## TVA Disposal Facility Assessment Phase 1 Plant Summary Bull Run Fossil Plant (BRF)

**TVA Disposal Facility Assessment  
Phase 1 Coal Combustion Product Disposal  
Facility Summary  
Bull Run Fossil Plant (BRF)  
Bottom Ash Disposal Area 1 (BAD-1)**

Drawing Mark BAD-1-1

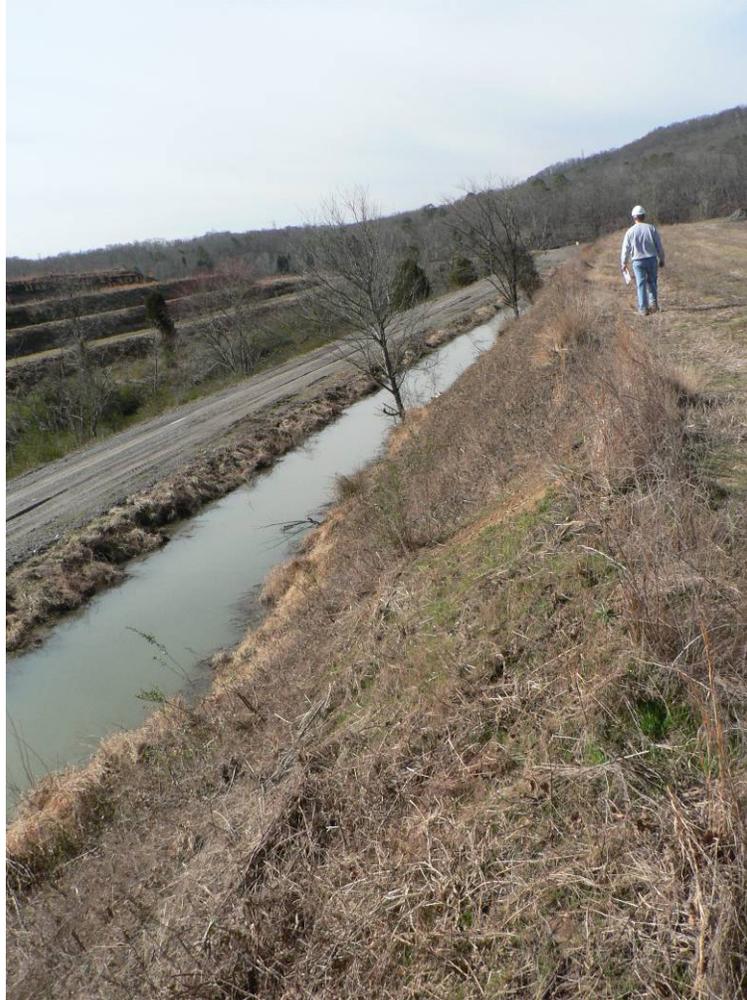
Typical side slope on west side of bottom ash stack showing standing water in drainage ditch.
